**ADDENDUM NO. 4**

**CONTRACT NO. 20-517**

**REHABILITATION OF GLEN ISLAND APPROACH BRIDGE  
OVER NEW ROCHELLE HARBOR (BIN 3348880)  
NEW ROCHELLE, NEW YORK**

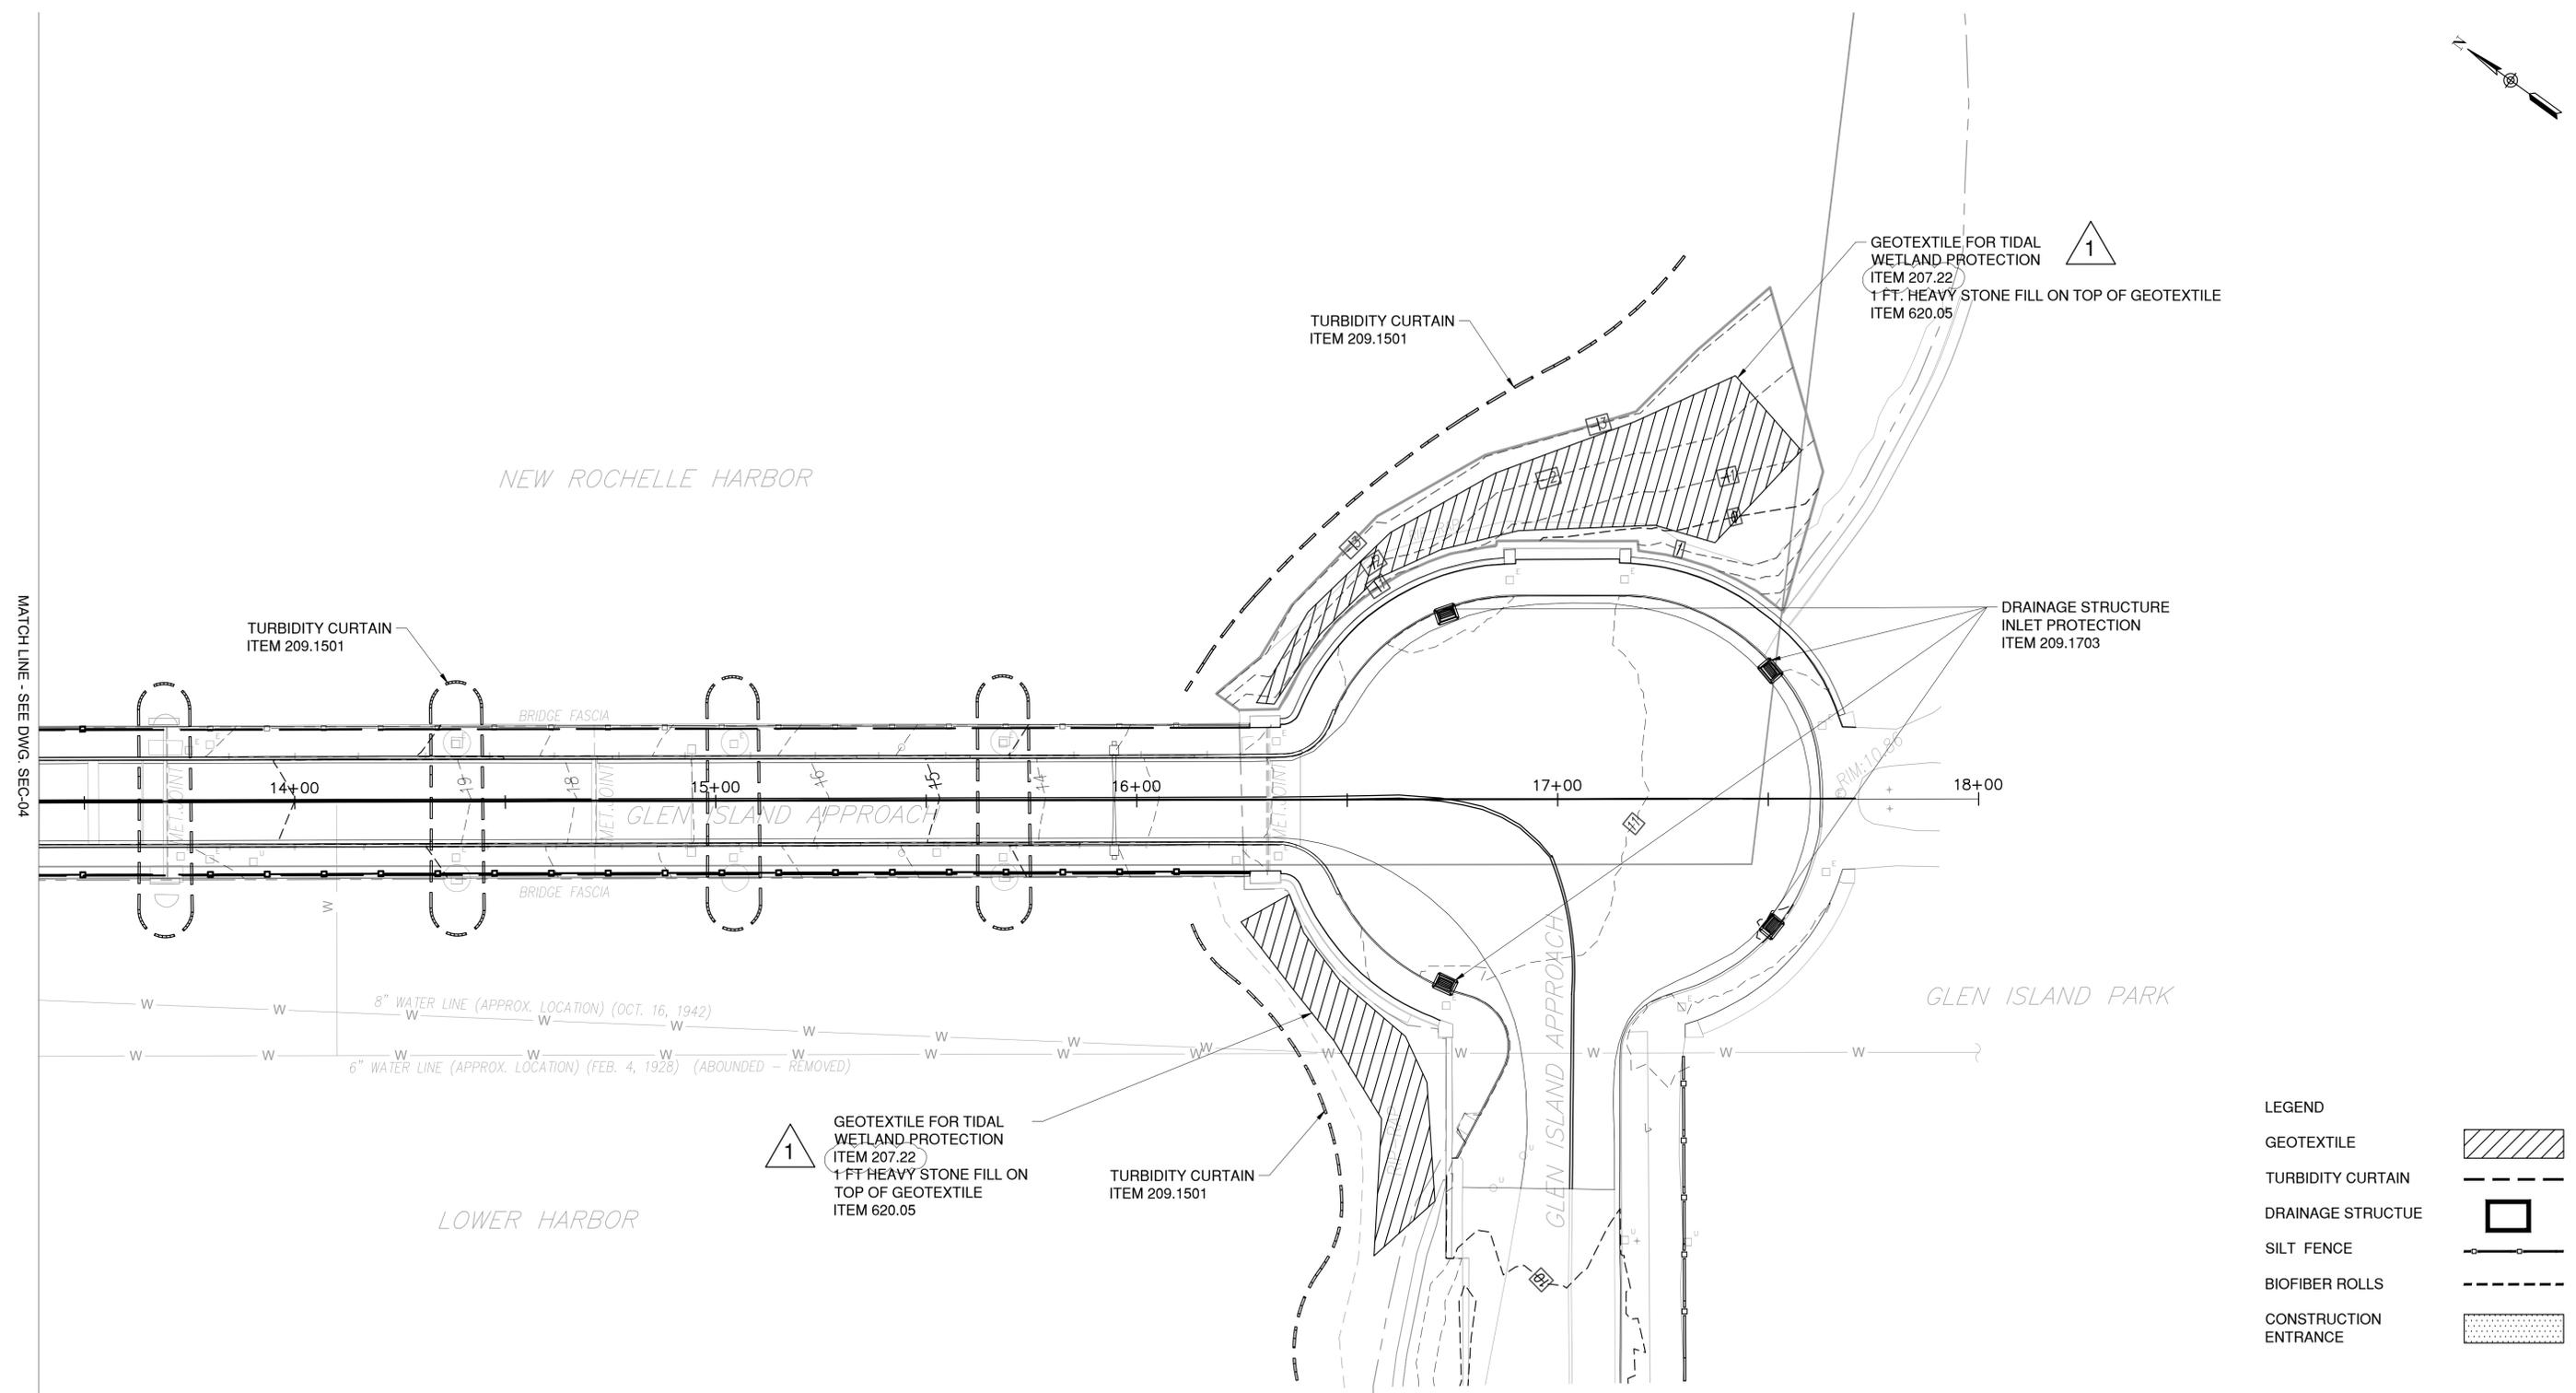
REVISION NUMBER	DATE	MADE BY	APP'D BY	REVISION
1	4/12/24	JD	KH	201.06 ADDED, 203.02 REVISED

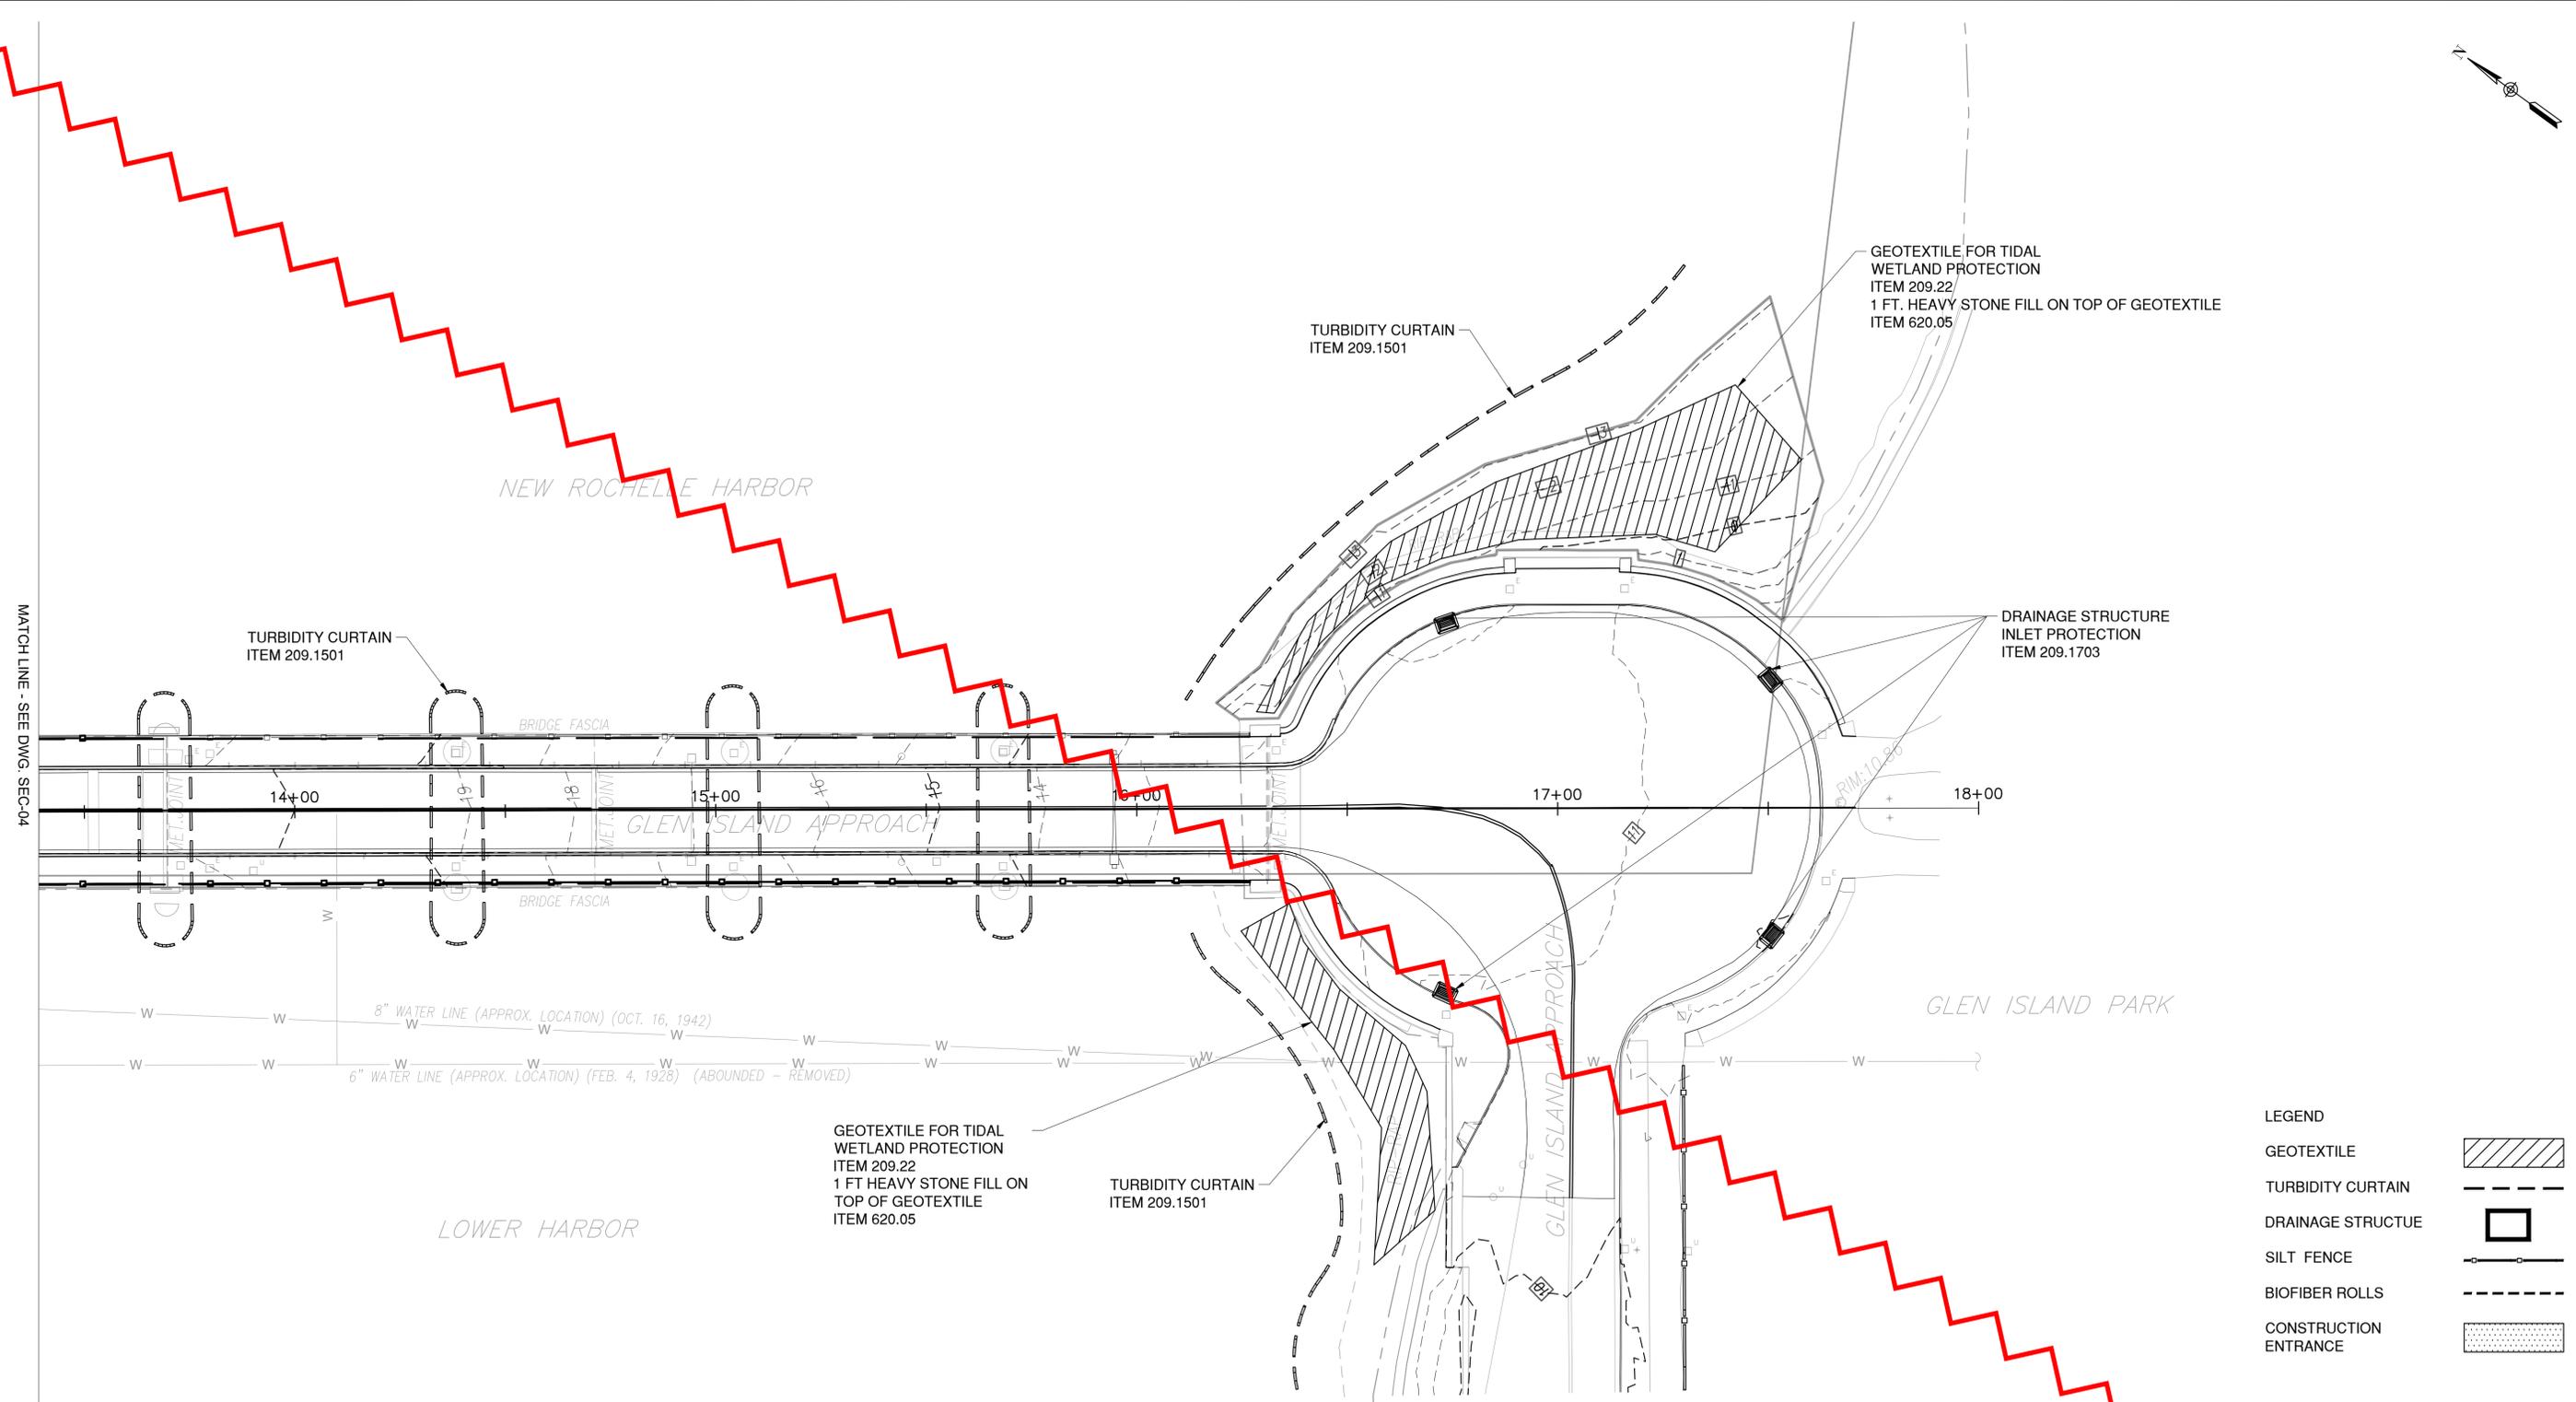
047	006	RCC	Dwg: SEC-05 shows "Geotextile for Tidal Wetland Protection" under Item 209.22. Please confirm that is the correct bid item.	Item should be 207.22. See Addendum #4 for revised drawings.
048	006	RCC	Please confirm drilling and grouting anchor bolts for bearings will be paid under the corresponding bearing items.	Drilling/grouting of anchor bolts is only anticipated to be required at Pier 14. At this location, drilling and grouting will be paid for under the corresponding bearing item. At all other piers, the height of the pier top rebuild is tall enough to accommodate casting the anchor bolts into the new concrete and drilling/grouting will not be required.
049	006	RCC	Please confirm drilling and grouting epoxy coated rebar will be paid under 556.0202	Confirmed.
050	006	RCC	Refer to sheet GP-01, the proposed crosswalk line striping is called out as "PROPOSED CROSSWALK, TYPE LS (TYP) ITEM 685.070200410, ITEM 685.07200510", however those items are not shown to have LS units within the Itemized Proposal, rather they are shown to have LF units. Please clarify, and amend if necessary, if the proposed crosswalk is to be paid for as a Lump Sum or per LF.	Proposed crosswalk shall be paid for per linear foot (LF) as correctly shown on our drawings. The 'LS' refers to the Type of Crosswalk (combined standard ladder bar) based on NYSDOT Standard Sheet 685-01 Pavement Marking Details (Sheet 2 of 9)

REVISION NUMBER	DATE	MADE BY	APP'D BY	REVISION
1	4/11/24	LS	IW	GEOTEXTILE ITEM NUMBER
